PREVOST

**WARRANTY
BULLETIN**

Wb09-23

DATE: JANUARY 2010	SECTION: 23 - Accessories
EXPIRATION: JANUARY 2012	
SUBJECT: PREHEATER EXHAUST PIPE HOLDING CLAMP

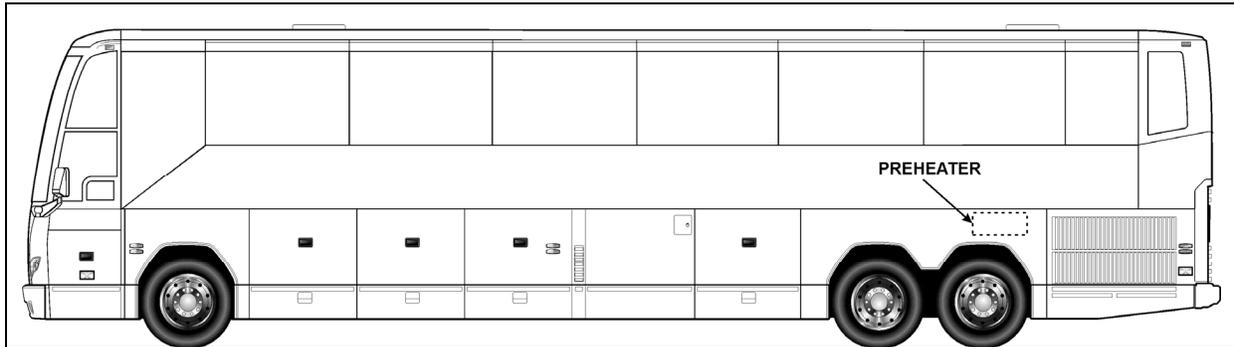
On the vehicles affected by this bulletin and equipped with a preheater, there is a possibility that the clamp holding the preheater exhaust pipe be not properly positioned.

Make sure that holding clamp is located above splash guard panel and not beneath.

**WRONG
INSTALLATION**

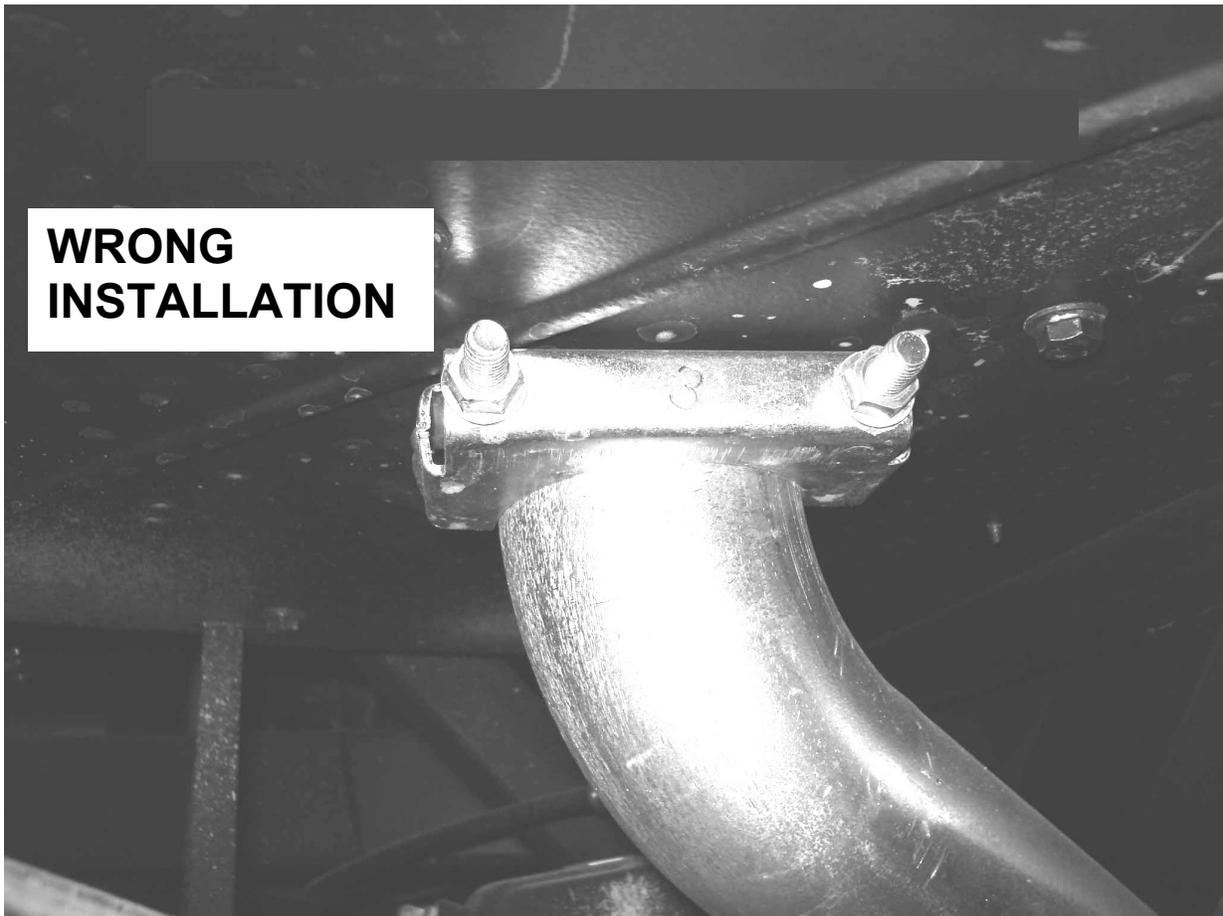
1. Check if the clamp holding the preheater exhaust pipe is located above or beneath the splash guard panel. This splash guard panel is located above the tag axle L.H. side wheel.
2. In the case where the clamp is located under the panel, it must be removed and repositioned.
